Hall D Civil and Cryogenic Issues

Ravi Anumagalla

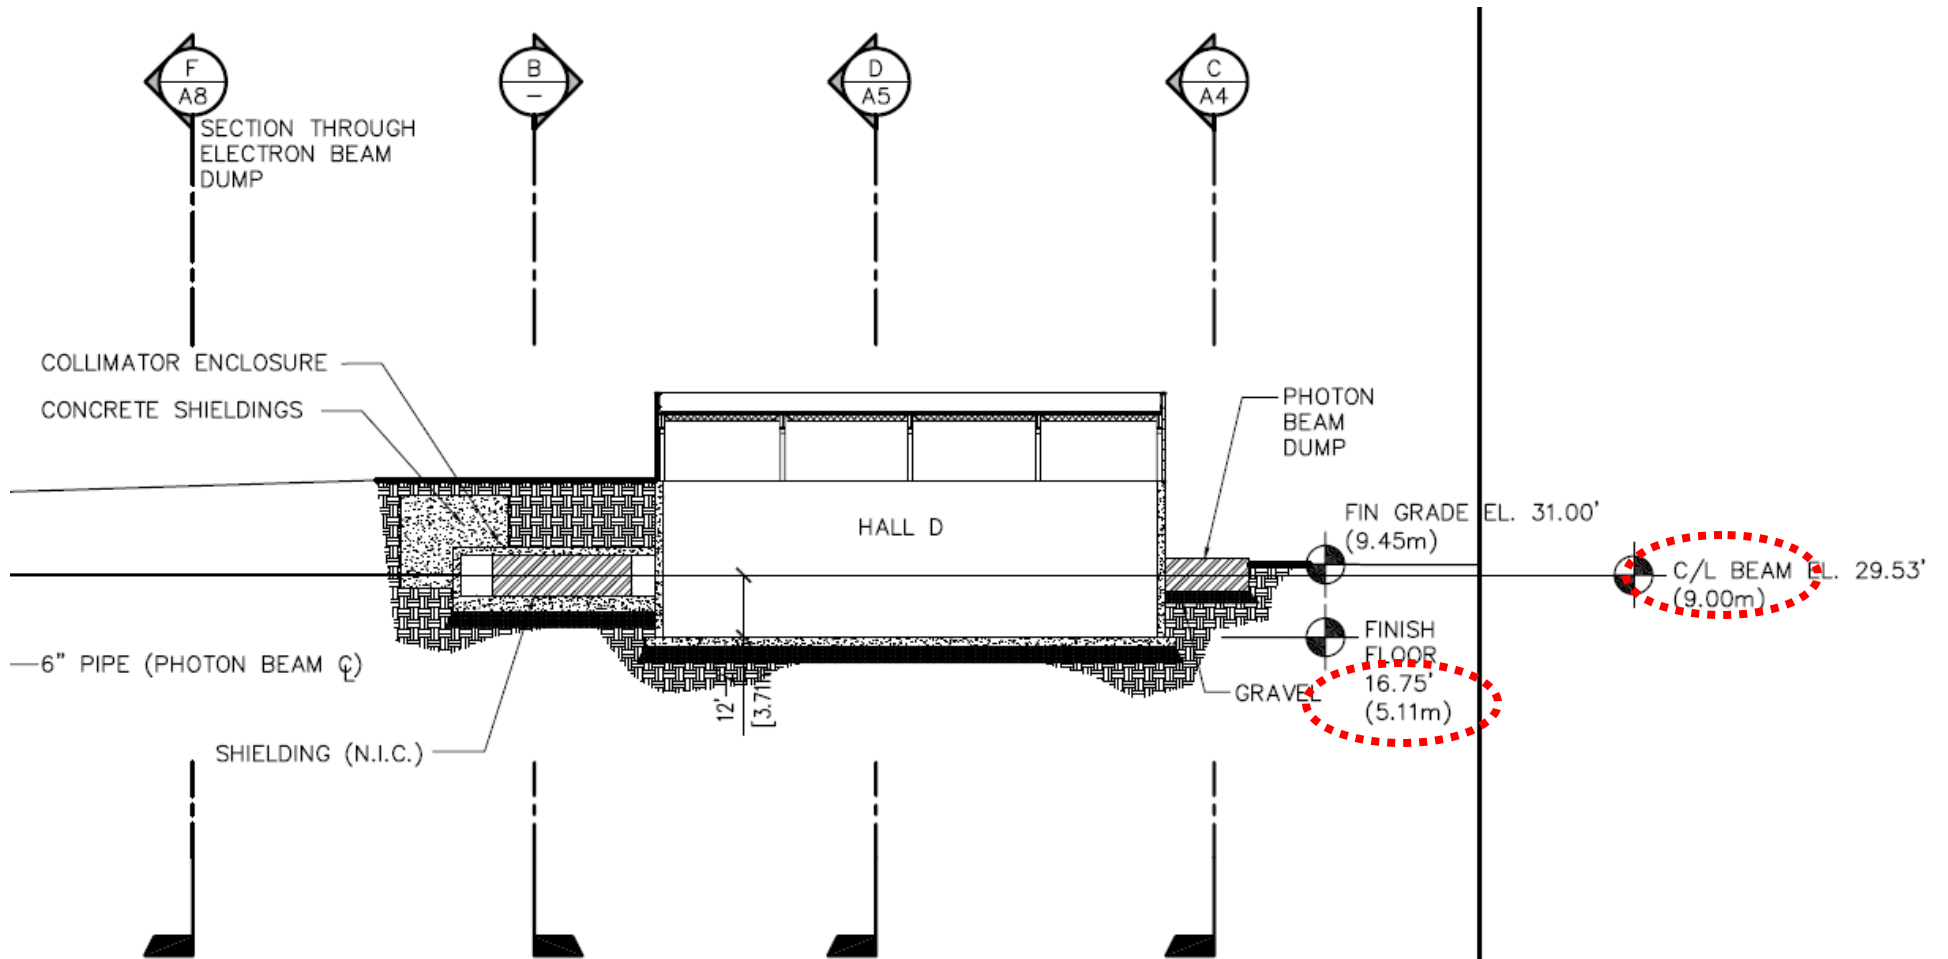
The Required Crane Hook Height wrt Finish Floor is **10 m** or higher.

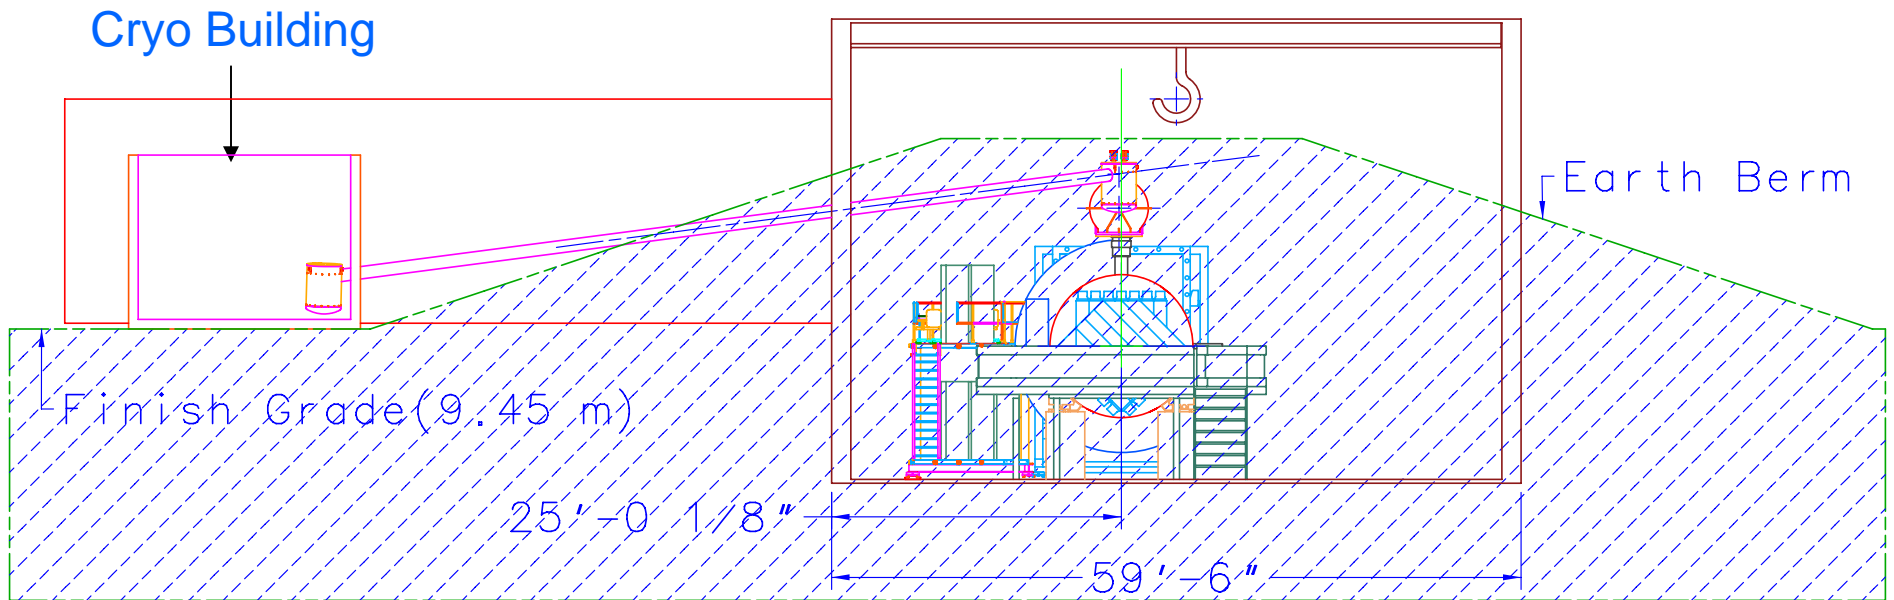
The Required Beam Height wrt Finish Floor is 3.5 m, Civil Drawings show a height of 3.89 m (9.00-5.11).

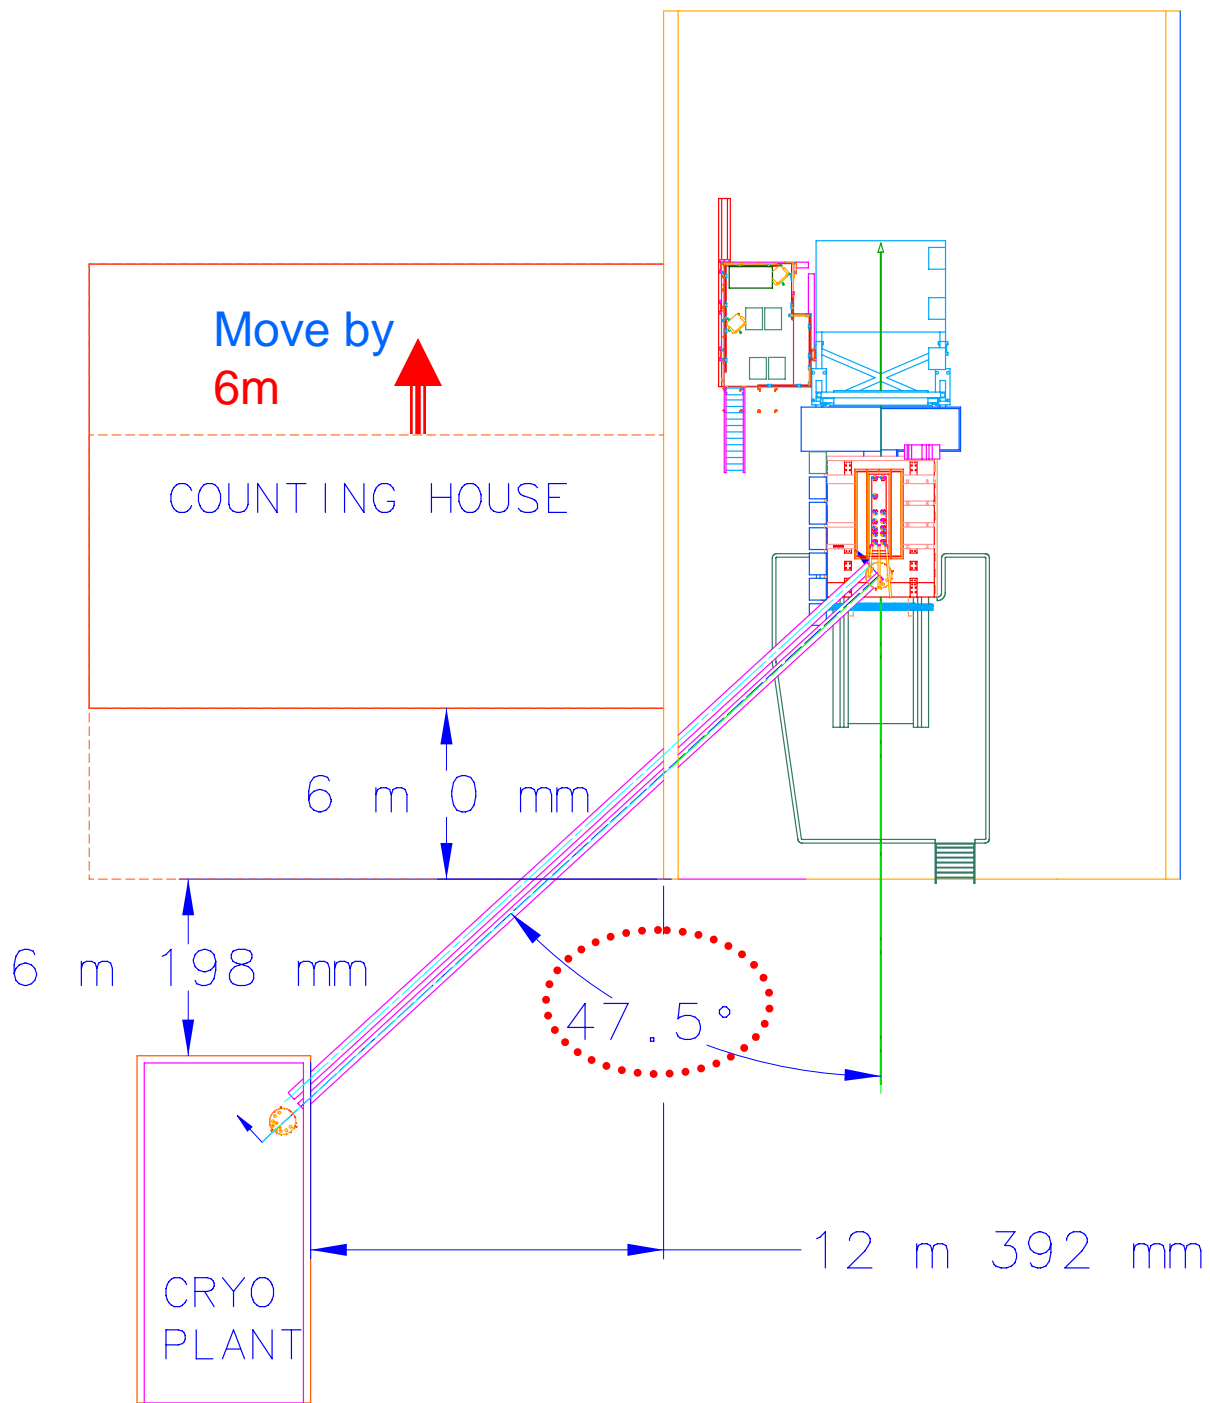
- The Cryo Building is exactly located at the end of the Earth Berm
- The length of the Transfer line required for this setup is **91 ft (27.5 m)**

- Counting House should be moved by **6 m** to facilitate the installation Transfer Line
- A **47.5 Deg** Angle for the transfer line fits perfect to the current location of the Cryo Building

Transfer Line Orientation

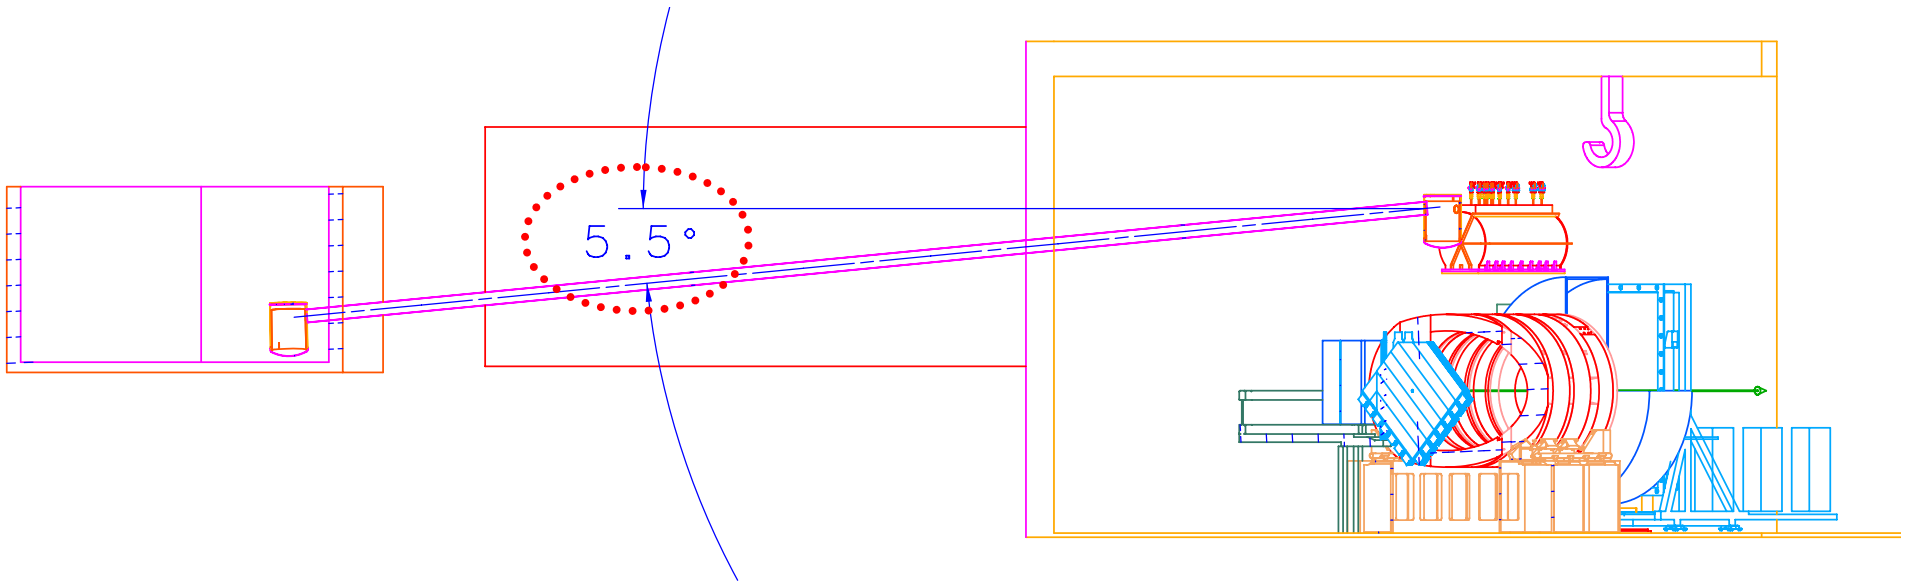
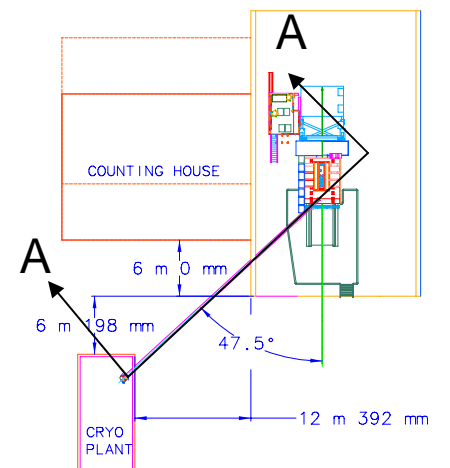
The Transfer line is at angle of **5.5 Deg** wrt to the horizontal

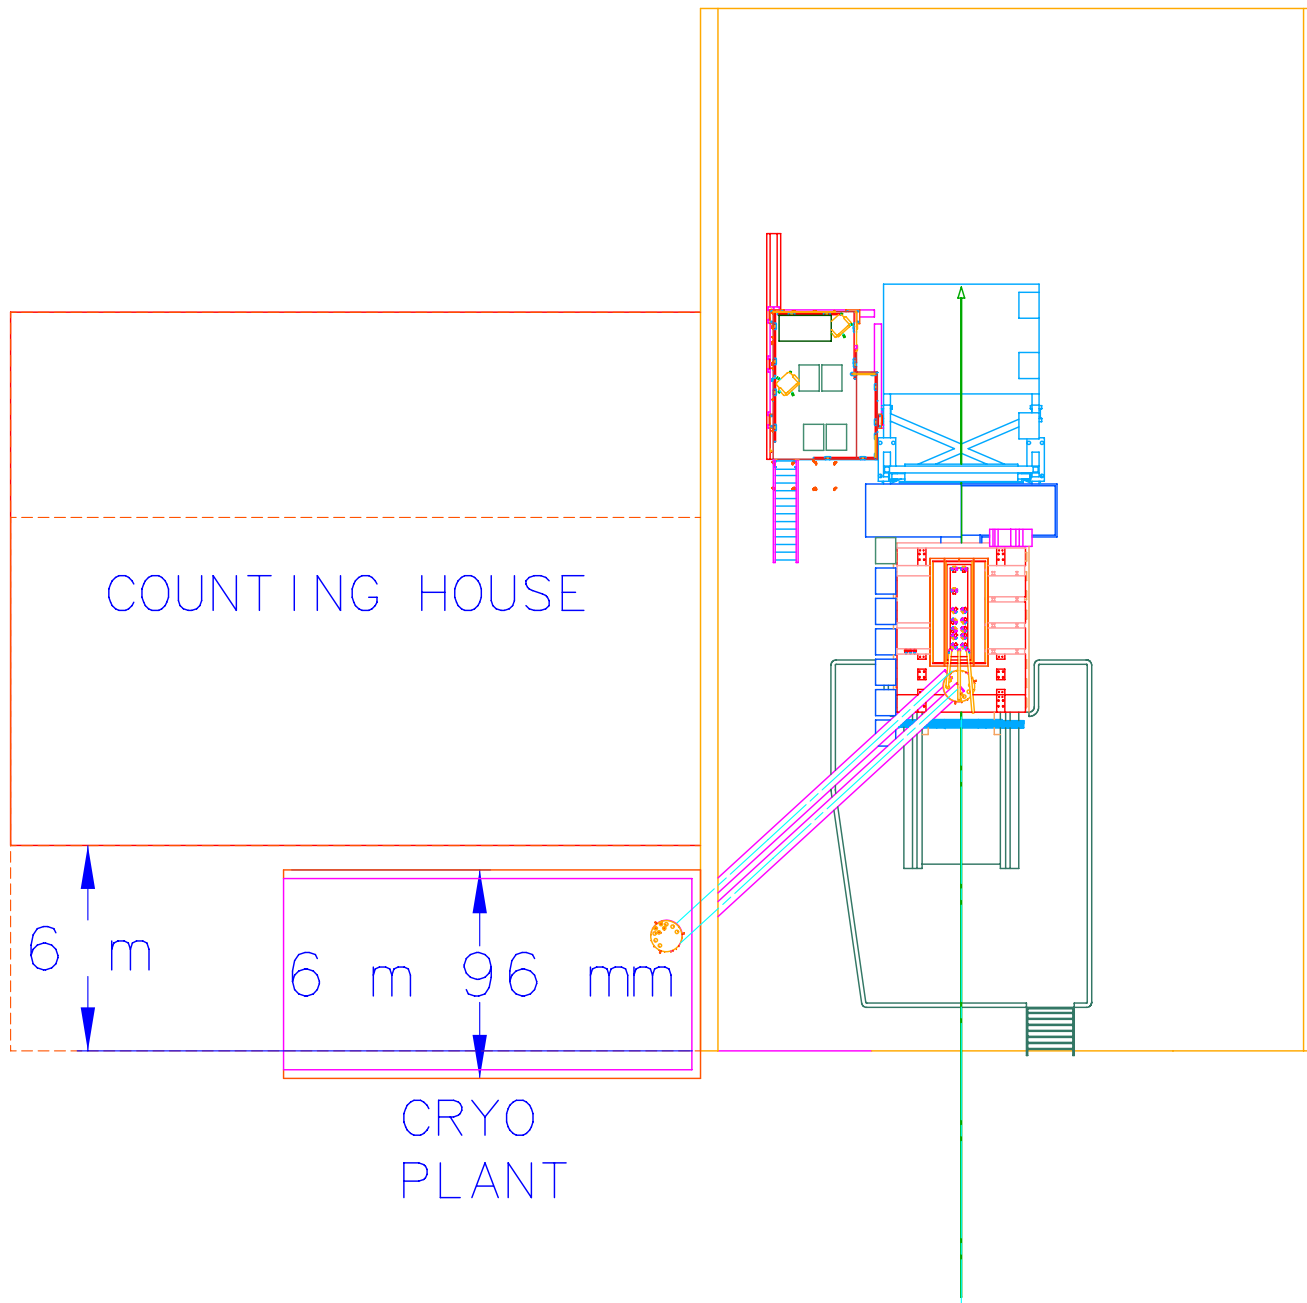
- Counting House should be moved by **6 m** to facilitate the installation of Transfer Line
- With the current setup, the length of the transfer line reduced to **9.5 m** compared to **27.5 m** with the earlier setup.

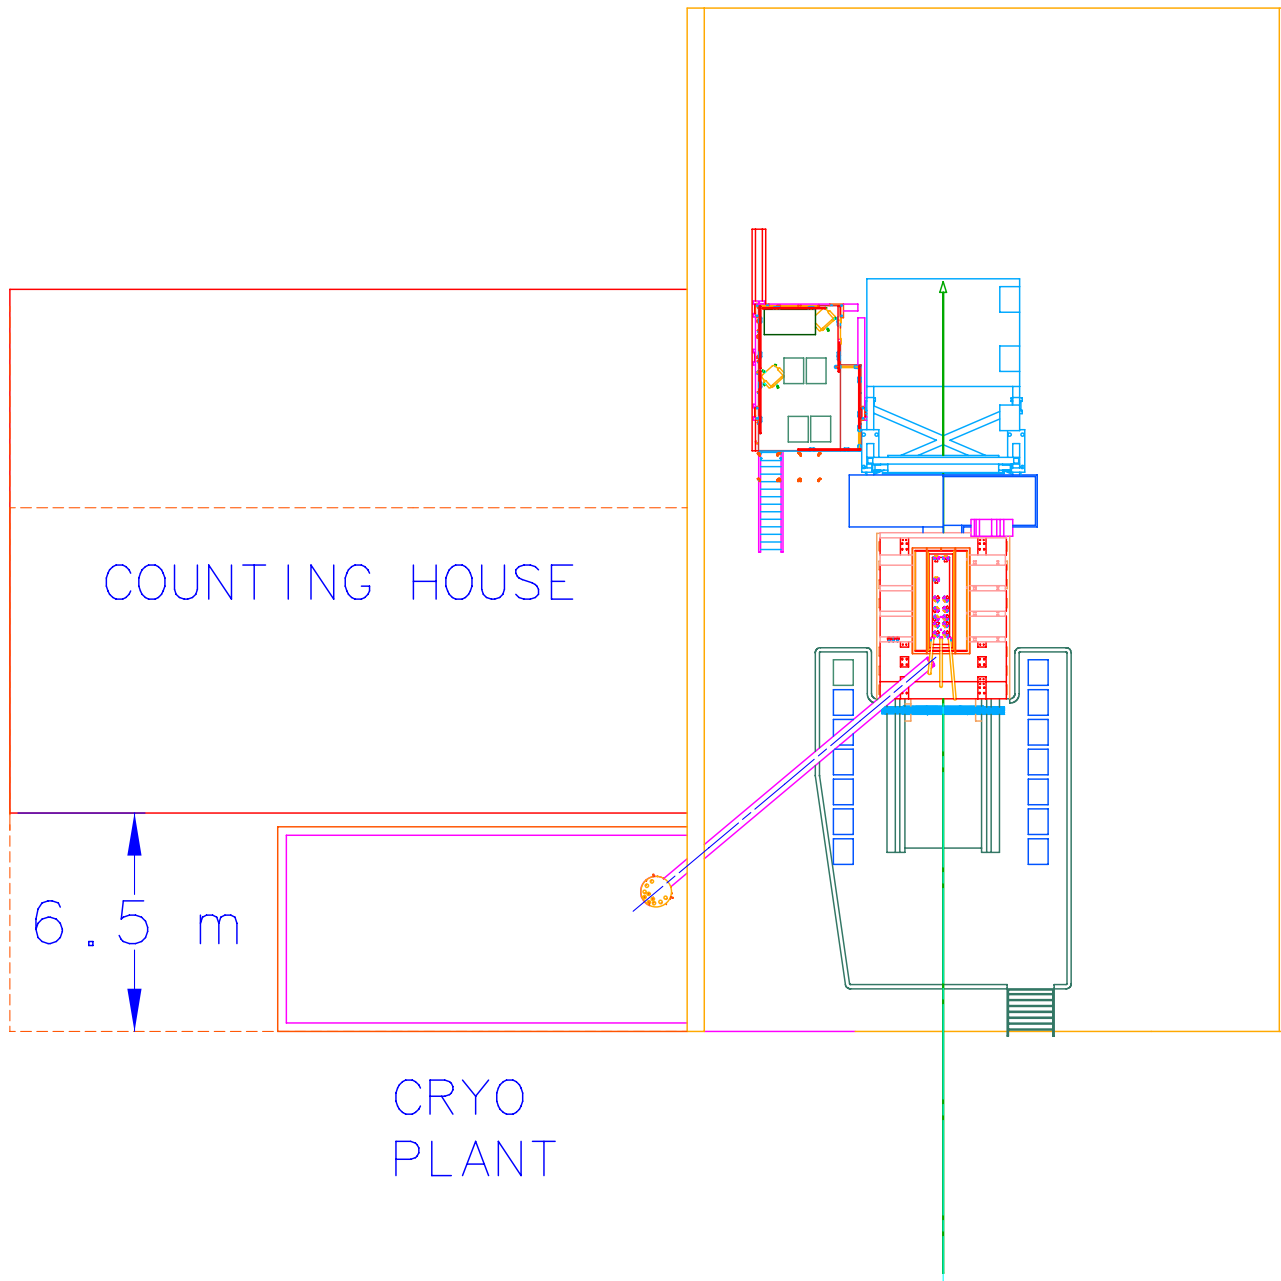
- Counting House should be moved by **6.5 m** to facilitate the installation of Transfer Line
- With the current setup, the length of the transfer line is reduced to **9.5 m** compared to **27.5 m** with the earlier setup.
